### **m e m o r a n d u m**

**FROM:** Marcus Ricci, Planner II

**DATE:** April 7, 2017

**SUBJECT:** **2017-LBDRB-01:** A request by Chris Saunders, Vision Housing, LLC, for design review of a residential development at 802, 804, and 806 South Lincoln Avenue and 809 West Nevada Street.

A1.3

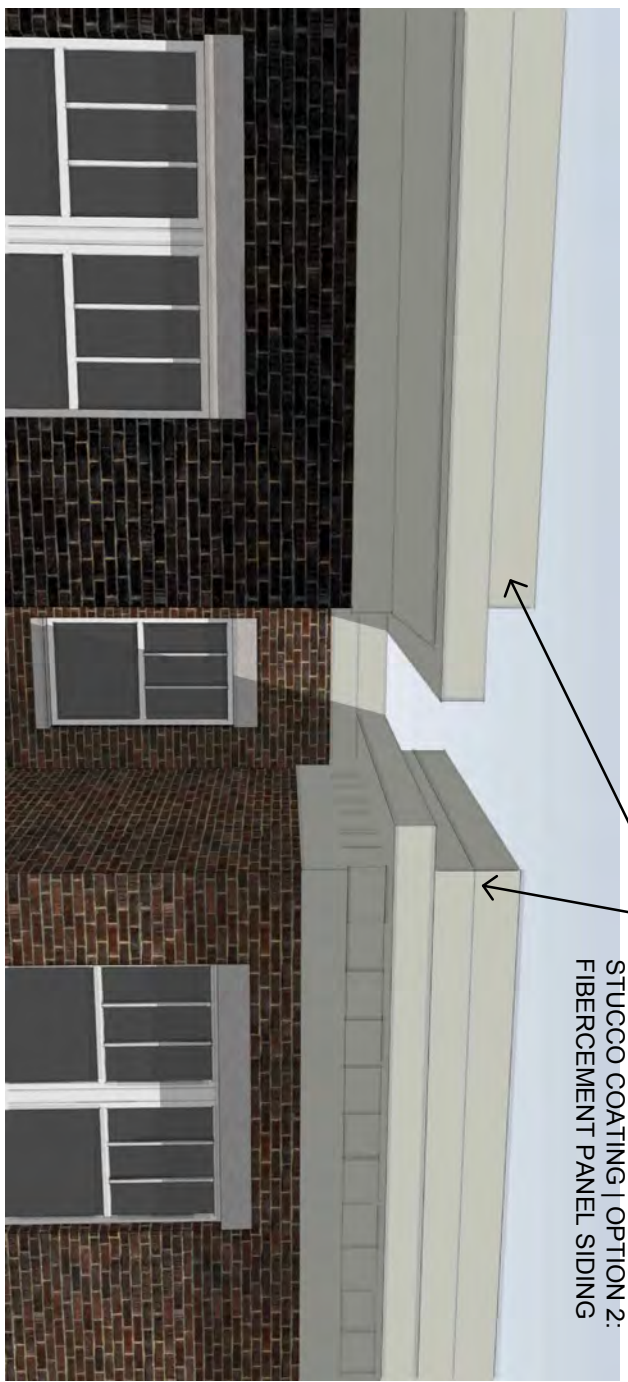
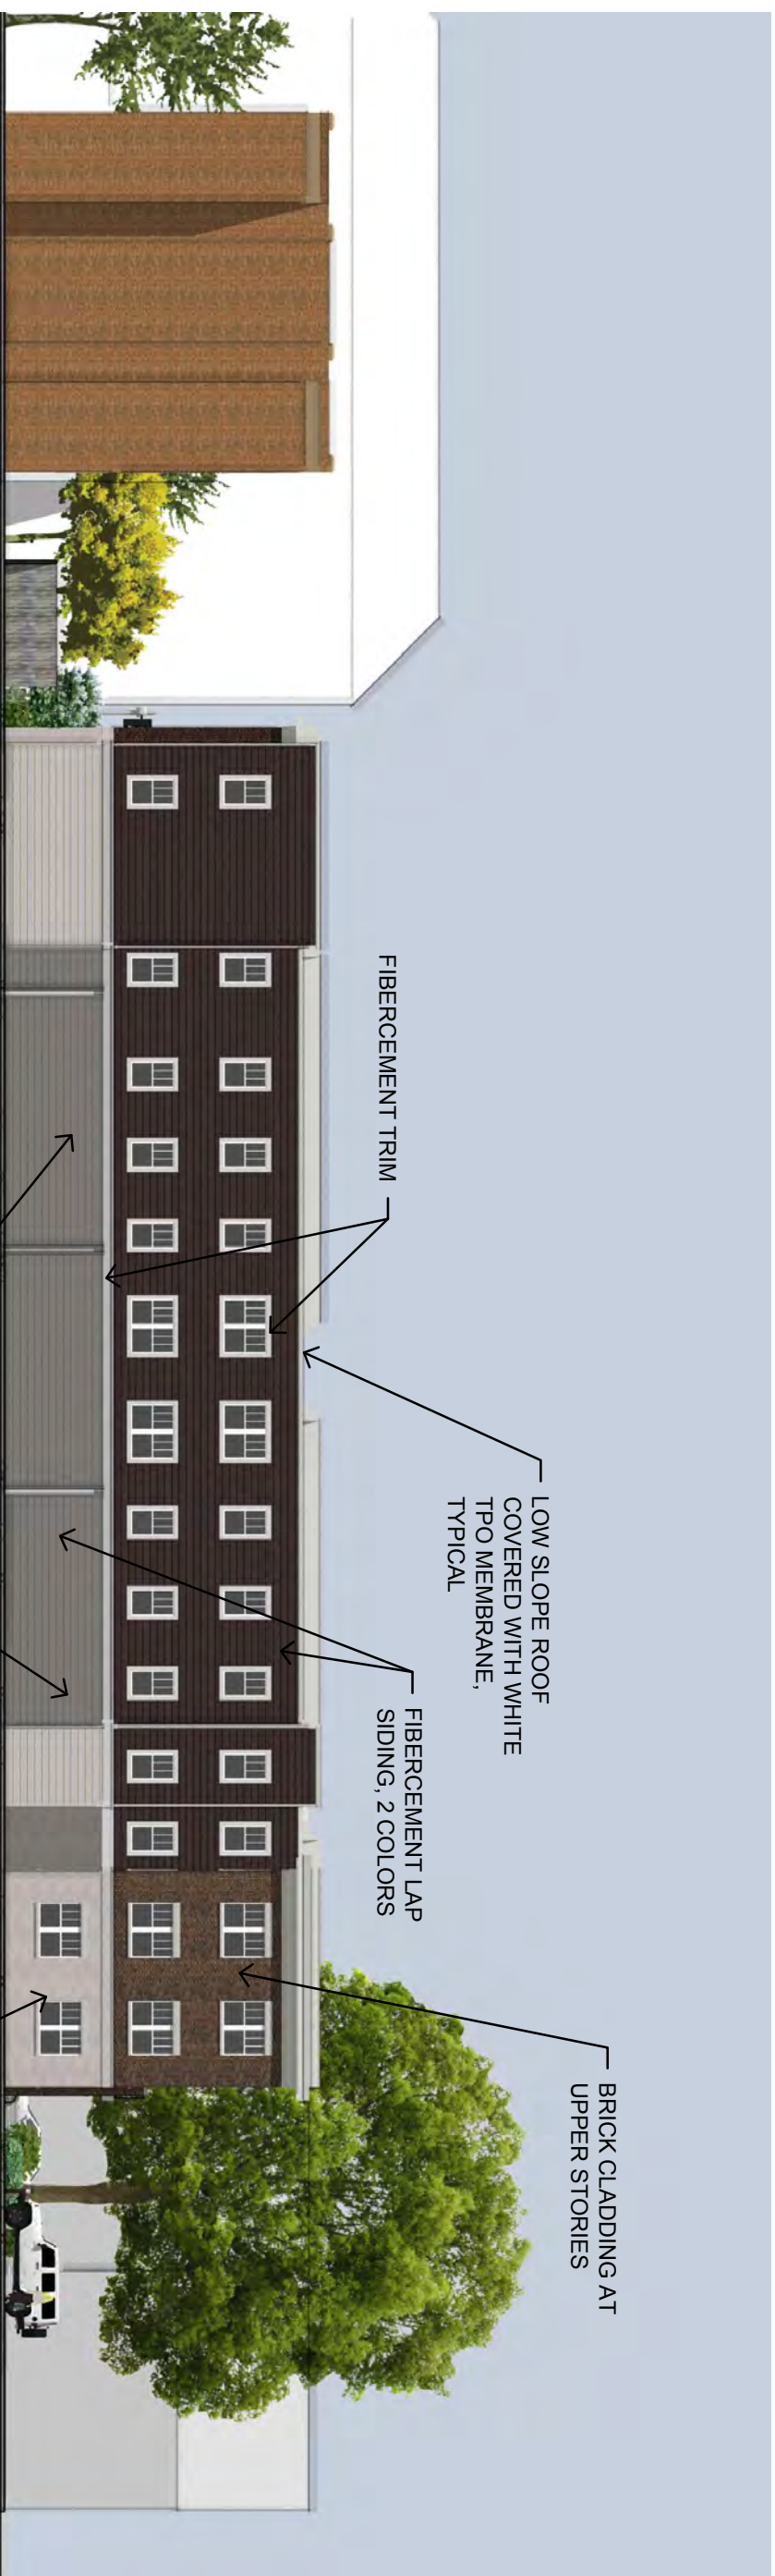
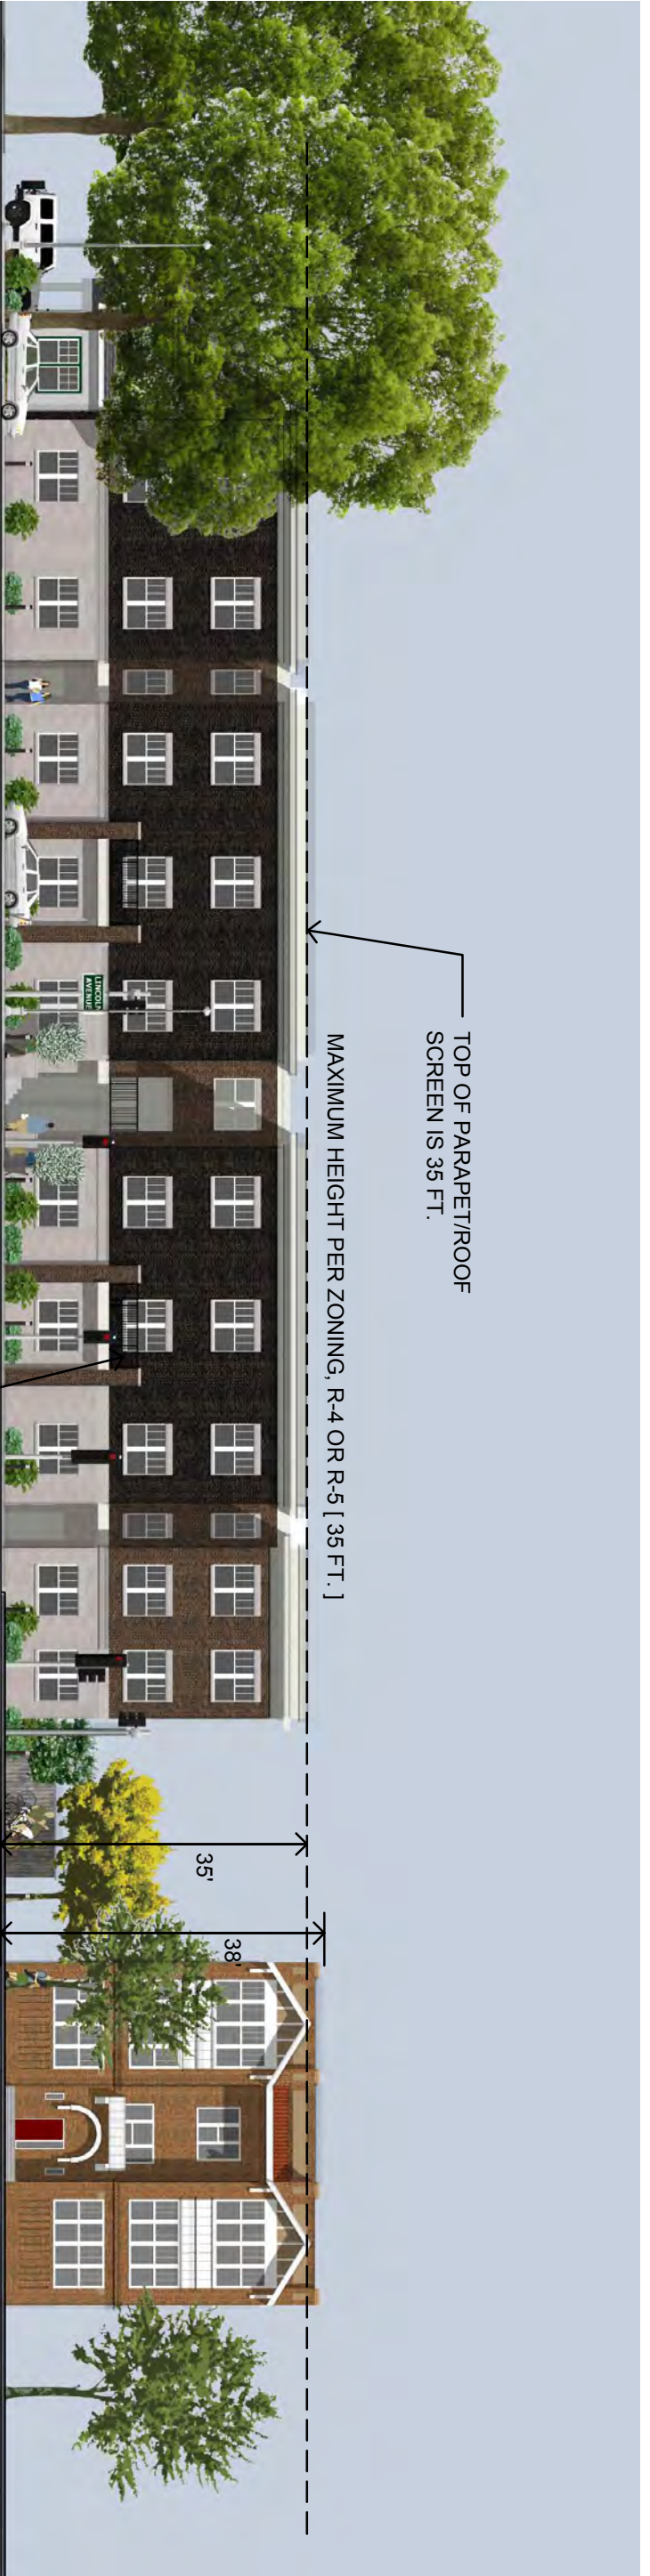
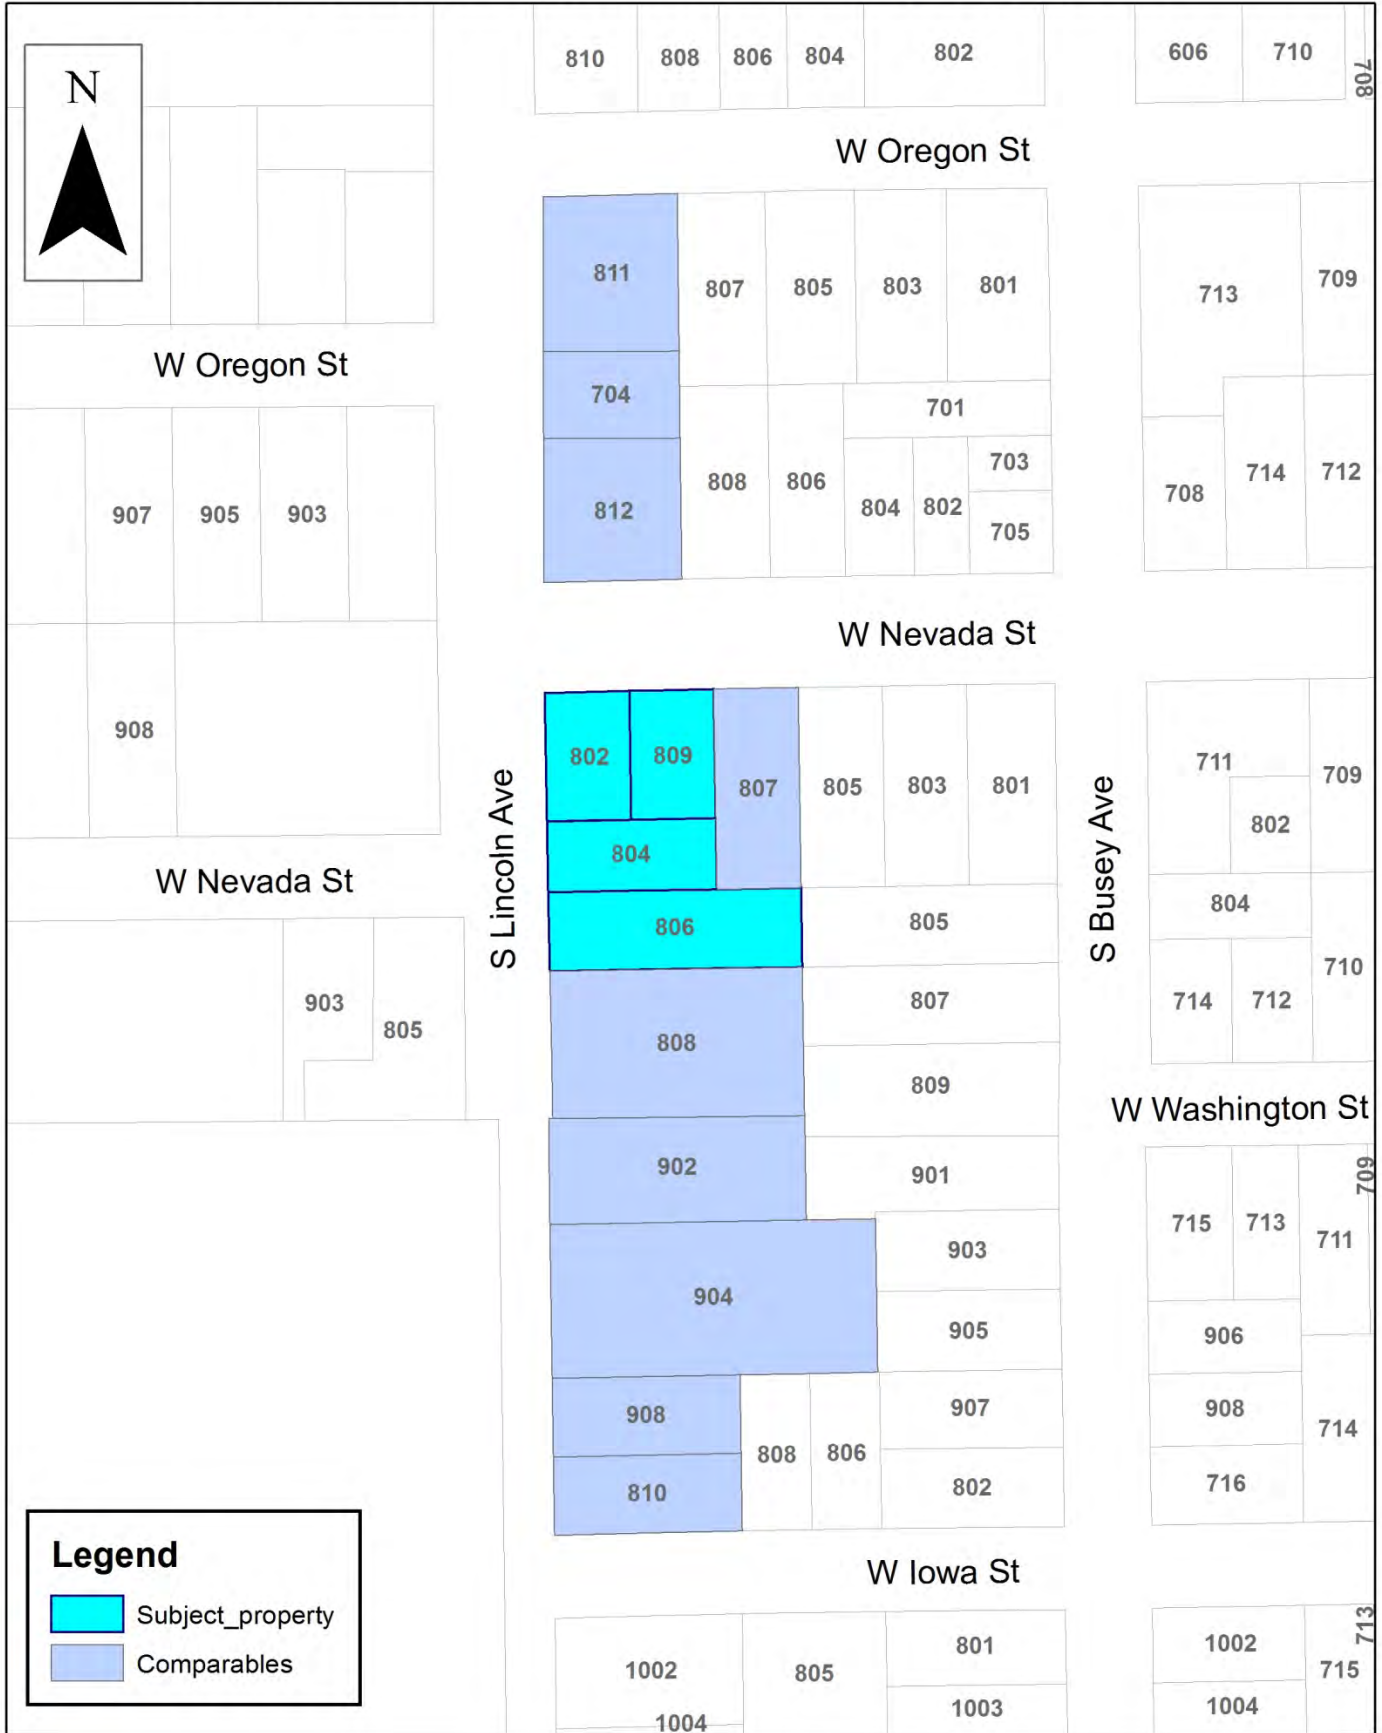
- The proposed building’s South Lincoln Avenue façade will have an outdoor courtyard living area as its focal point and will be equipped with benches and landscaping to act as a common space for residents and guests (Exhibit C, Sheet A1.3.).
- The proposed private balconies do not dominate the façade zone, and are oriented or screened so that they are not visible to passersby.
- There are no sliding glass doors on the ground floor that are visible in the façade zones.
- There are two large landscaped lawns areas on the west and north sides of the building and smaller landscaped areas adjacent to the parking area. Some areas are visible to the public while others are set back in the rear yard.
